**LAKE MANITOBA AND LAKE
ST. MARTIN OUTLET CHANNELS
PROJECT
Environmental Impact Statement
May 2023 Project Description
Update**

**PROJECT DESCRIPTION
UPDATE**

**LAKE MANITOBA AND LAKE ST. MARTIN OUTLET CHANNELS PROJECT
ENVIRONMENTAL IMPACT STATEMENT
MAY 2023 PROJECT DESCRIPTION UPDATE**

Figure 3C-12a LMOE Typical Bridge Elevations and Cross-Sections – PTH 6 Bridge

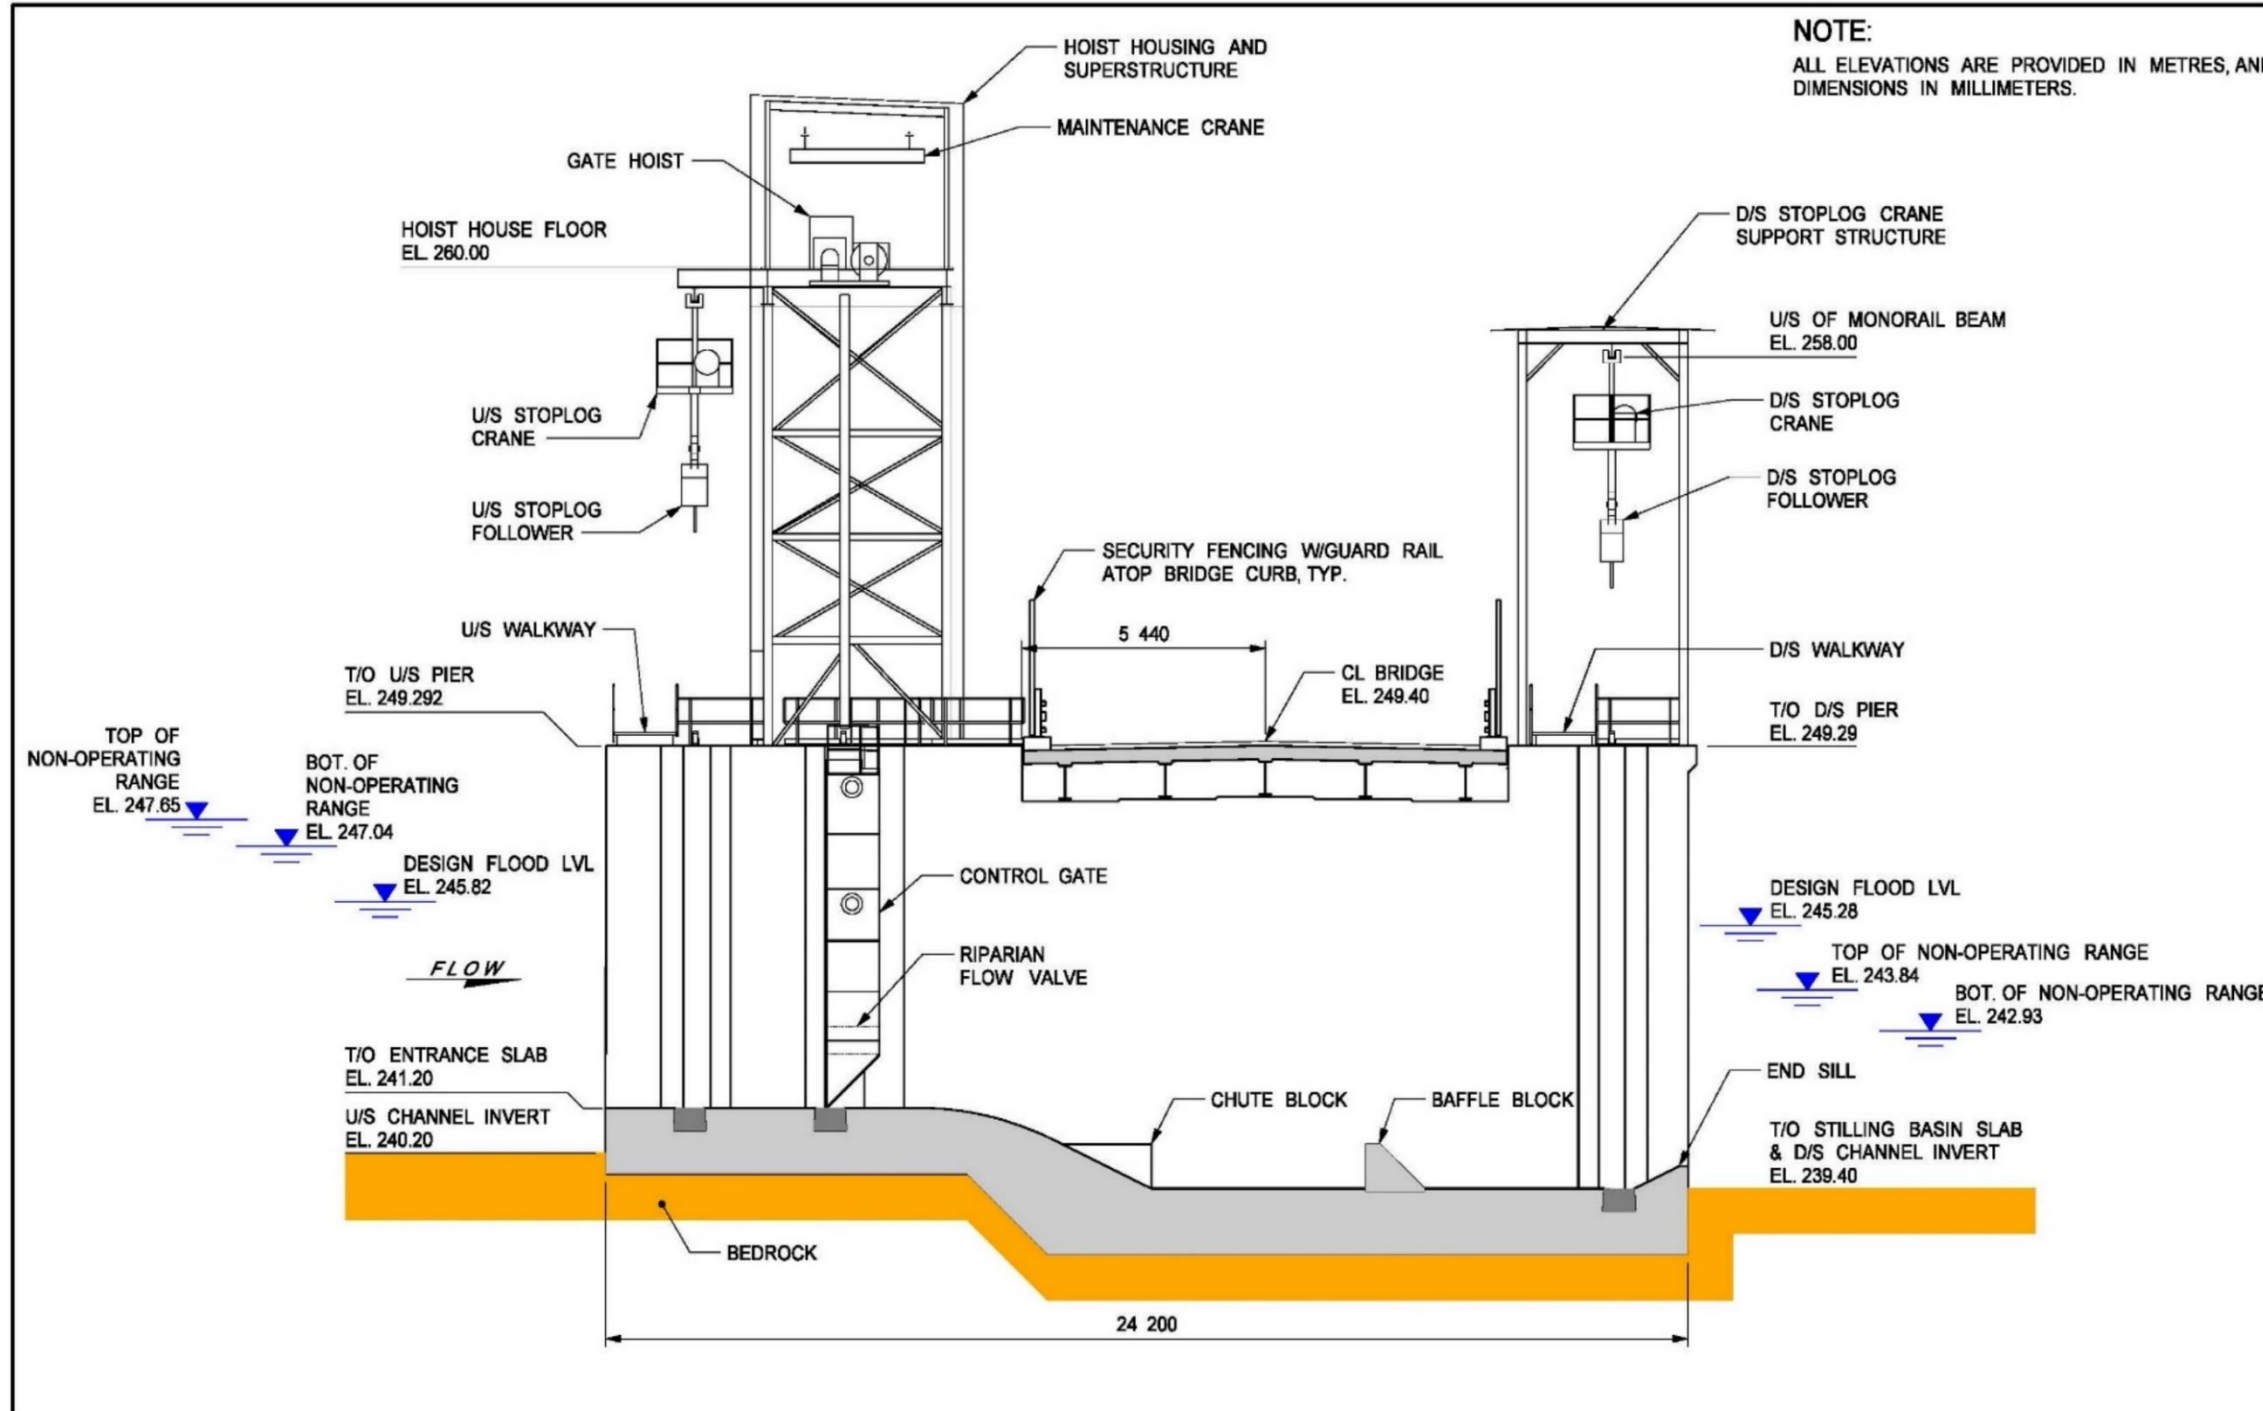
Several refinements in WCS design have been made since the March 2020 Project EIS, as shown in Appendix 3C, Figure 3C-11a, 3C-11b, and 3C-11c. The WCS is still designed with three sluice bays, guides, and sill beams for upstream stoplogs, vertical lift gates and downstream stoplogs; however, the bays are now narrower (5.4 m [17.7 ft], down from 9 m [29.5 ft]) and a stoplog crane and support structure have been added downstream of the bridge deck. The WCS will have a base slab founded on bedrock to support the mass of the concrete substructure and a stilling basin with baffle blocks. The stilling basin and baffle blocks are designed to absorb or dissipate the energy from the flowing water and protects the downstream area from erosion.

Figure 3C-15a Typical Cross-Section of LSMOC – Type A

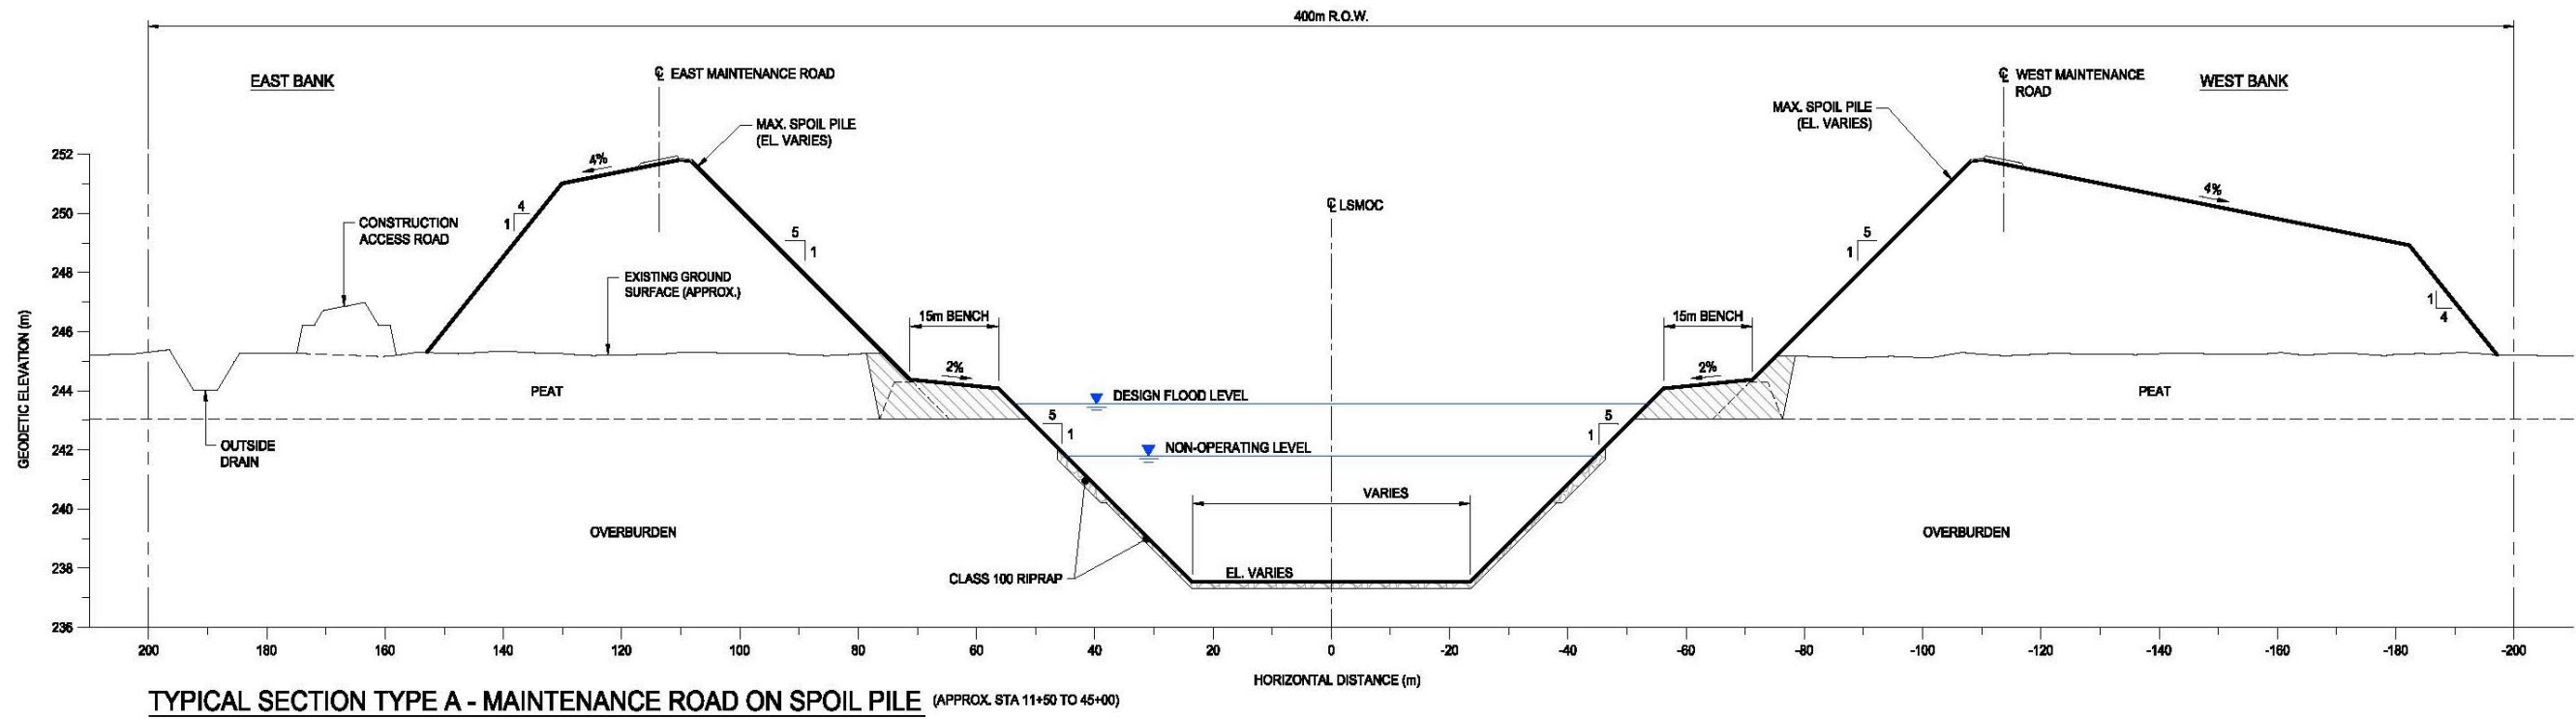
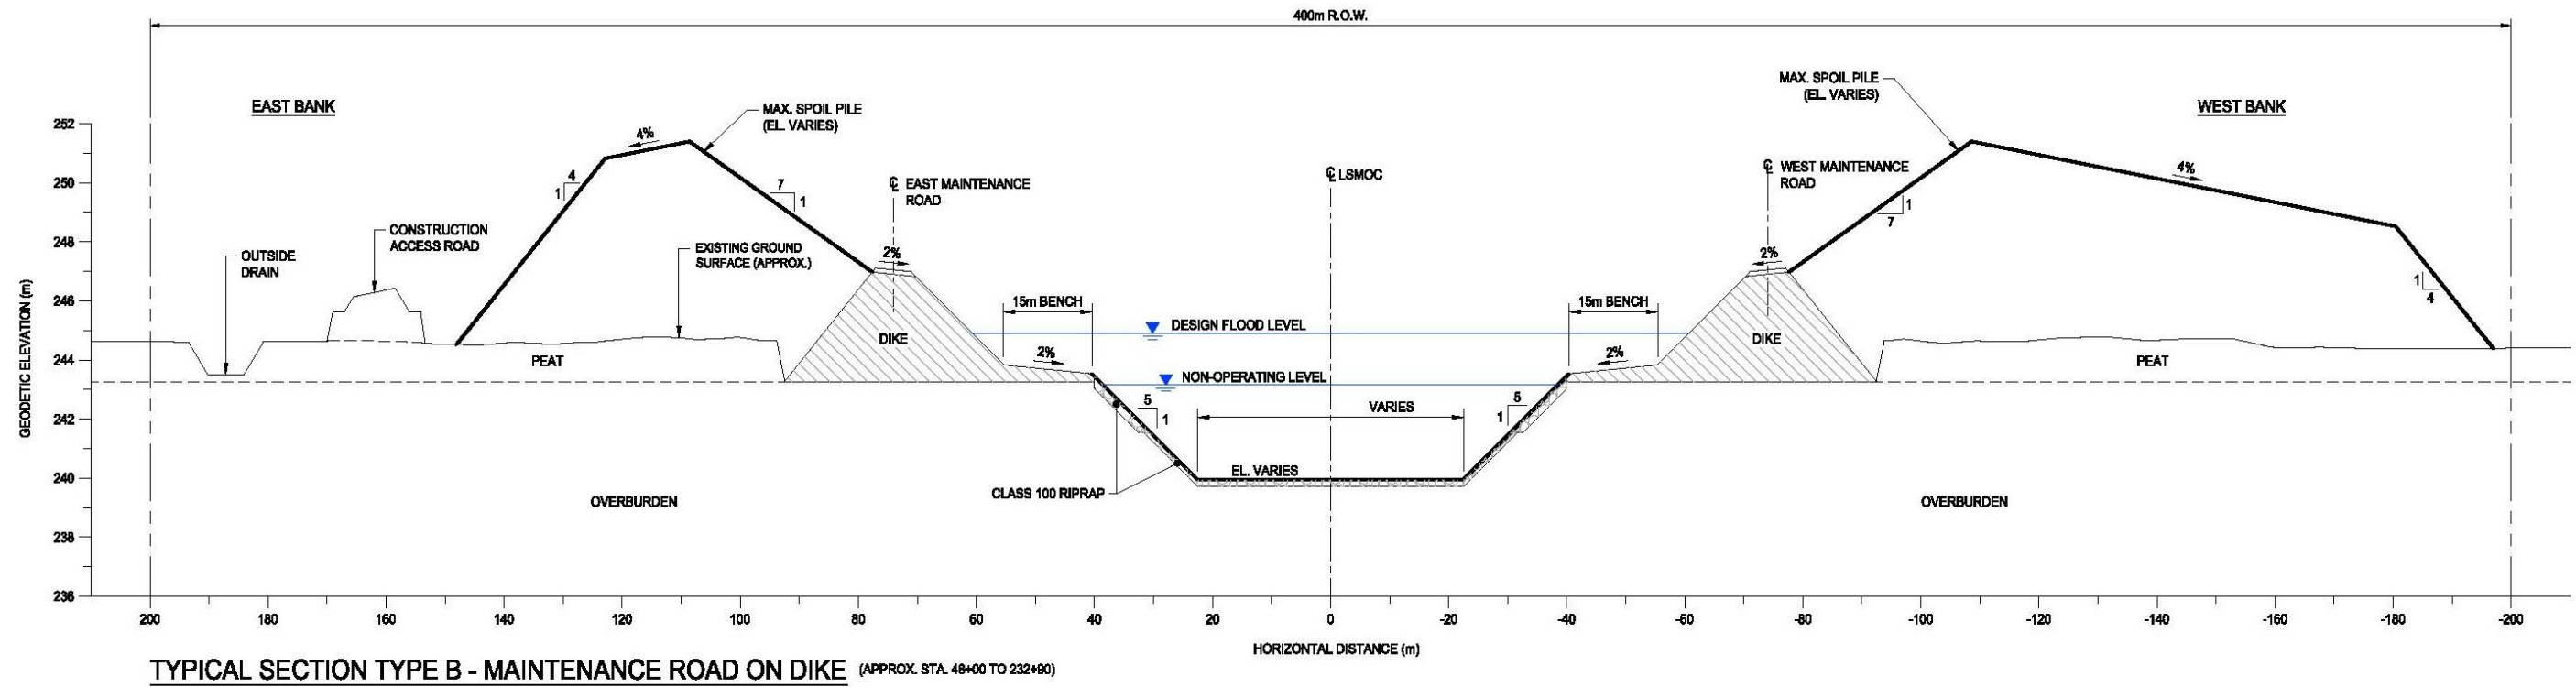
The March 2020 Project EIS describes a uniform trapezoidal cross-section with a base width of about 44 m (144.4 ft) and 4H:1V side slopes. The refined design includes a modified trapezoidal shape with a bench located part way up the side slope. The bench height will vary, and will approximately follow the clay elevation (i.e., the underside of the peat). The side slopes will now be 5H:1V. The base width will vary over the length of the LSMOC. From the WCS to the first drop structure, the base width will generally be 45 m (147.6 ft), with the exception of a short segment immediately downstream of the WCS where the base width will be 47 m [154.2 ft]. Downstream of the first drop structure, the base width will generally be 35 m (114.8 ft), with the exception of the segment between the third and fourth drop structures where the base width will be 59 m (193.6 ft).

As shown in Appendix 3C, Figure 3C-15a and 3C-15b, permanent water-retaining dikes will be located on both sides of the excavated channel to contain design flows within the LSMOC and also to isolate the surface water and the upper saturated peat system from the excavated channel. These will have a maximum height approximately 3m [9.8ft] above ground surface, with a typical top width of approximately 6m. Spoil piles for the excavated material will be located outside of the channel dikes. Final spoil pile geometry will be determined by the contractor and depend on a number of factors such as material properties, compaction, and hauling distance. Access for long-term maintenance and inspection will be obtained via maintenance roads on top of the dikes on both sides of the LSMOC for the entire 23.8 km (14.8 mi) length.

Figure 3C-16 LSMOC Profile

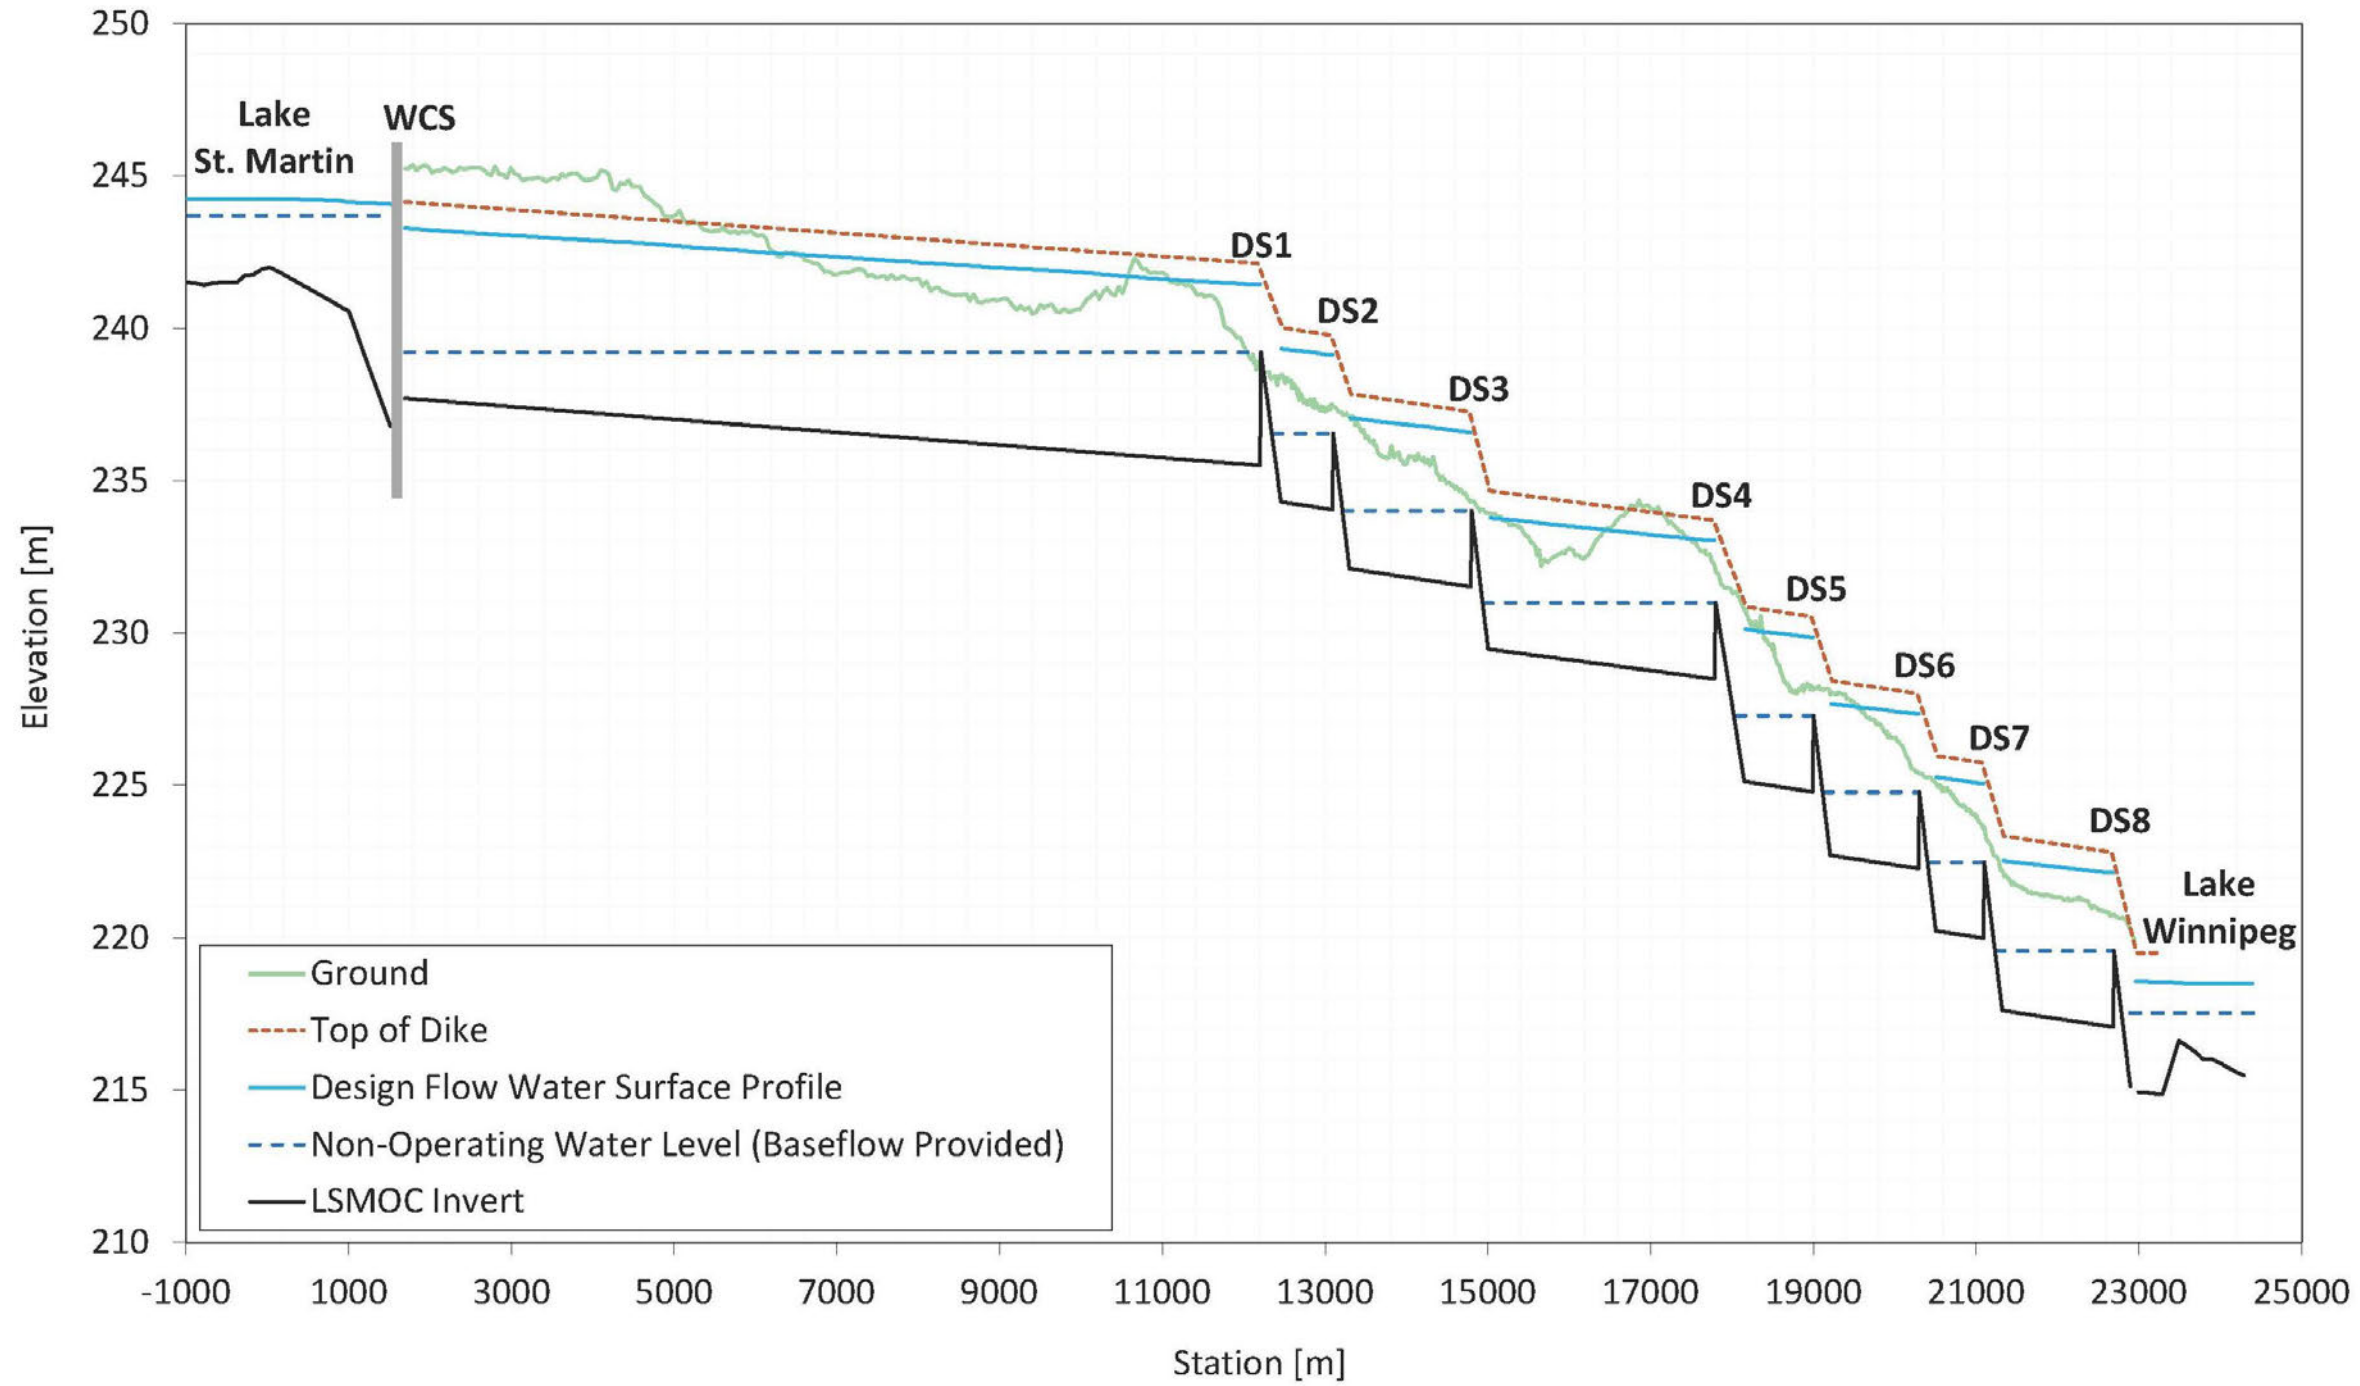
The length of the channel will remain at approximately 23.8 km (14.8 mi), but there have been some refinements in current channel design for the LSMOC that have been made since the March 2020 Project EIS. Appendix 3C, Figure 3C-15a, 3C-15b, and 3C-15c show the current cross-section of the LSMOC channel, and design refinements are summarized below. Refinements from the March 2020 EIS include lowering the invert between the WCS and Drop Structure 1 (to increase conveyance to account for the head loss through the Lake St. Martin Narrows¹³ and modifying the invert slope to optimize the channel geometry with armouring. The channel invert slope now ranges from 0.021% (upstream of the first drop structure) to 0.04% (downstream of the first drop structure). The channel will have a bottom elevation of approximately 240.5 m asl (789.04 ft asl) at the shoreline of Lake St. Martin and 214.9 m asl (705.05 ft asl) at the shoreline of Lake Winnipeg (see Appendix 3C, Figure 3C-16).
